REQUEST FOR INFORMATION **DATE:** November 27, 2016 **NO.:** RFI-359

Project Name: 15051-Webster University Interdisciplinary Science Building

Subject: Site Walls - General Questions

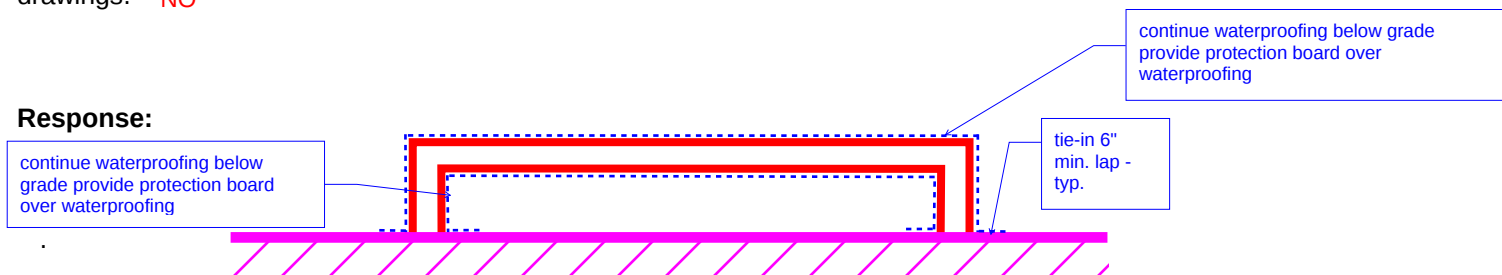
1. Provide detail where retaining walls butt existing concrete foundation wall. When this occurs - does the wall tie in, expansion joint material installed or modifications to waterproofing?
Provide #5x24" @ 12oc per "POST INSTALLED ANCHORS" notes S0001 at southwest corner of lecture hall (grids V-3) and mech area well (grids E.5-8).
Provide waterproofing at retaining wall butting to building's foundation walls at north area window well similar to east retaining walls documented in A0505. See sketch below.
